Access Compliance Report Public Rights-of-Way (Curb Ramps)

Intersection ID: 22956Main Street: CANOEBROOK_RDCross Street: QUAIL_HOLLOW_RDLocation:NEADA ID: C5FE4D9C14D8Ramp Type: PerpDiagInitial Pass/Fail: FailOverall Compliance: NoSeverity Score: 37.5

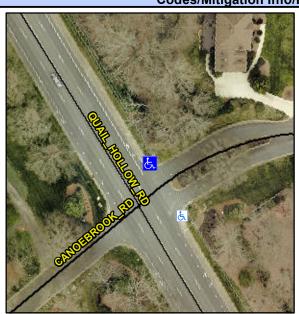
PROW/ADA:
Not Found, R304.2.2, R304.5.3

| Field Measurements/Component Compilance | | | | | |
|---|---|------|------------------------|-----------------------------|------|
| N/A | Ramp Length (in) | 59.0 | No | Ramp Slope (%) | 9.1 |
| Yes | Ramp Width (in) | 48.0 | No | Ramp XSlope (%) | 11.3 |

Remove & Replace Curb Ramp With
Two New Directional Ramps or
Equivalent.
